Access Compliance Report

Public Rights-of-Way

Intersection ID: 15096	Main Street: OLMSTED_PARK_PL	Cross Street: WINTHROP_AV	Location: NW
ADA ID: 4CFF3ACD84AE	Ramp Type: PerpDiag	Initial Pass/Fail: Fail	Overall Compliance: No
Severity Score: 13.75			
Codes/Mitigation Info/Possible Solution		Field Measurements/Component Compliance

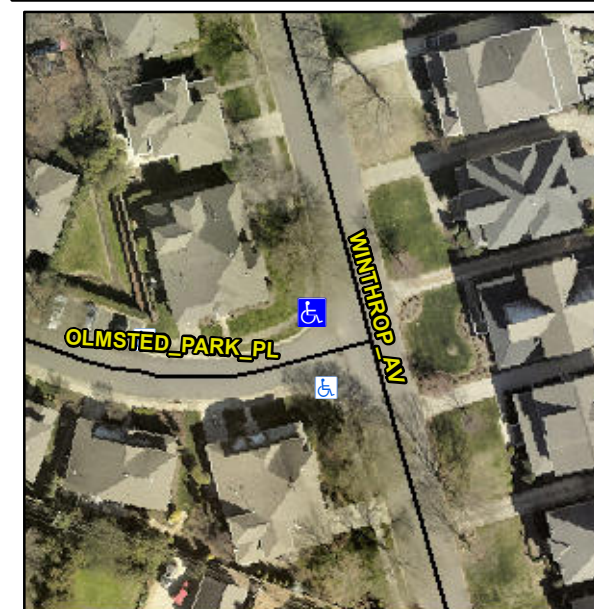
Not Found, R304.2.2, R304.5.3

Compliance	Description	Data	Compliance	Description	Data
N/A	Ramp Length (in)	49.0	No	Ramp Slope (%)	11.1
Yes	Ramp Width (in)	48.0	No	Ramp XSlope (%)	3.5
N/A	Flare Type LT	N/A	N/A	Flare Type RT	N/A
N/A	Flare Slope LT (%)	N/A	N/A	Flare Slope RT (%)	N/A
N/A	Flare Traversable LT?	N/A	N/A	Flare Traversable RT?	N/A
N/A	Landing Length (in)	N/A	N/A	DWS Provided?	N/A
N/A	Landing Width (in)	N/A	N/A	DWS Contrast?	N/A
N/A	Landing Slope (%)	N/A	N/A	DWS Length (in)	N/A
N/A	Landing X Slope (%)	N/A	N/A	DWS Full Width?	N/A
N/A	Landing Curb? (Y/N)	N/A	N/A	DWS Offset (in)	N/A
N/A	Shared Landing?	N/A			
N/A	Gutter Ponding?	N/A	N/A	Gutter Slope (%)	N/A
N/A	Gutter Lip Ht (in)	N/A	N/A	Gutter X Slope (%)	N/A
N/A	Painted X Walk1?	No	N/A	Painted X Walk2?	No
	X Walk 1 Direction	To S		X Walk 2 Direction	To E
N/A	X Walk 1 Width (in)	N/A	N/A	X Walk 2 Width (in)	N/A
	X Walk 1 Slope (%)	1.0		X Walk 2 Slope (%)	0.1
	X Walk 1 X Slope (%)	0.6		X Walk 2 X Slope (%)	2.3

Remove & Replace Curb Ramp With Two New Directional Ramps or Equivalent.
